REVIEW OF THE KINGSTON FOSSIL PLANT ASH SPILL ROOT CAUSE STUDY AND OBSERVATIONS ABOUT ASH MANAGEMENT

2008-12283-02
July 23, 2009

Peer Review of the AECOM Root Cause Analysis of TVA Kingston Dredge Pond Failure on
December 22, 2008

Stage 1 - Initiation of Failure at North Side of Dredge Cell 2

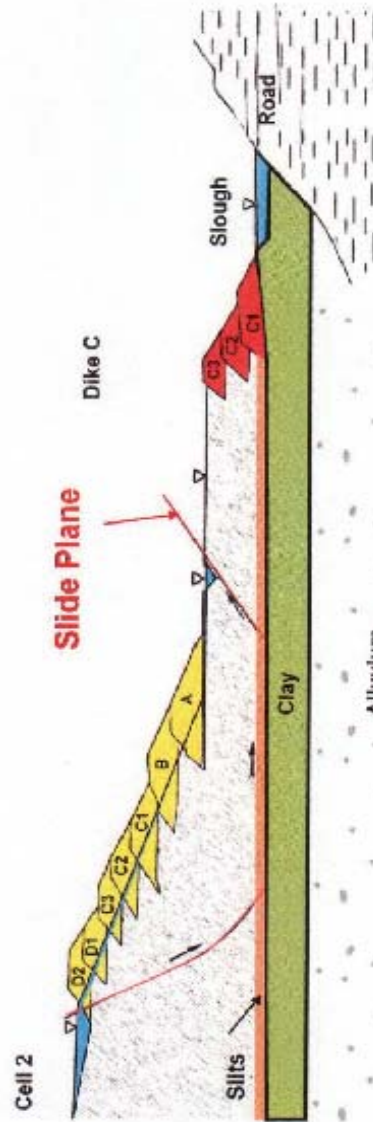
Figure 3 Stage 1 - Initiation of Failure at North Side of Dredge Cell 2

Stage 2 – Ash & Dikes A thru D2 Pile Up Against Dike C. This Surcharge and increased Ash Pressure Causes Dike C to Fail

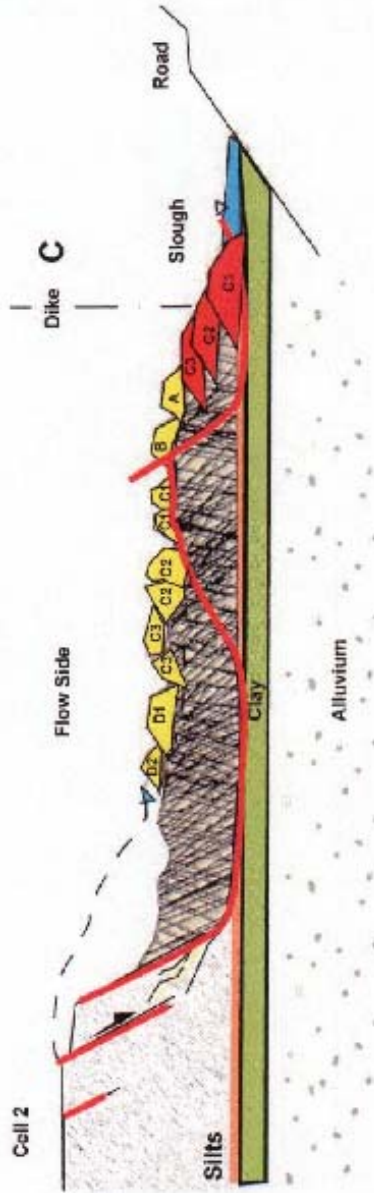
Figure 4 Stage 2 - Ash & Dikes A thru D21 Pile Up Against Dike C

Stage 3 – Progressive Failure Southward that Fails North Dikes A thru D2 Back to Cell 1 Divider Dike. 5.4 Million CY Fill Sloughs and Reservoir

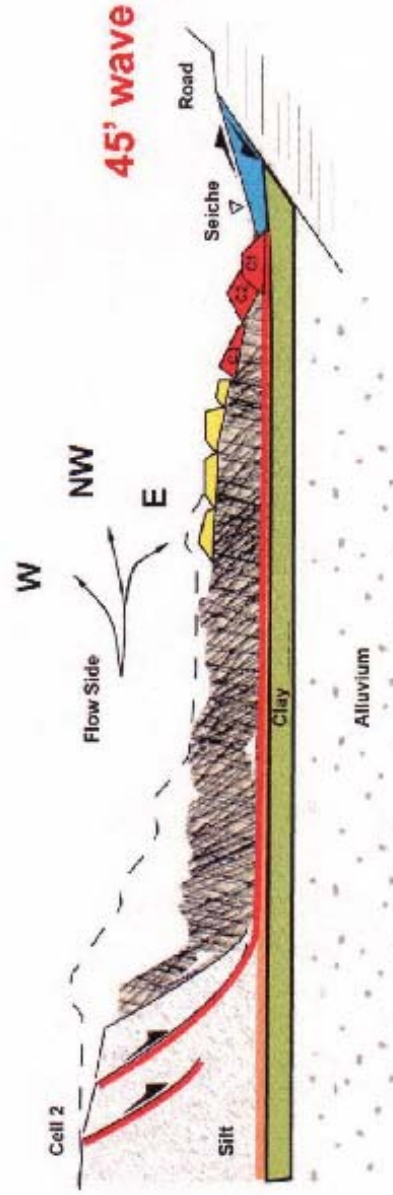
Figure 5 Stage 3 - Progressive Failure Southward that Fails North Dikes A thru D2 Back to Cell 1 Divider Dike
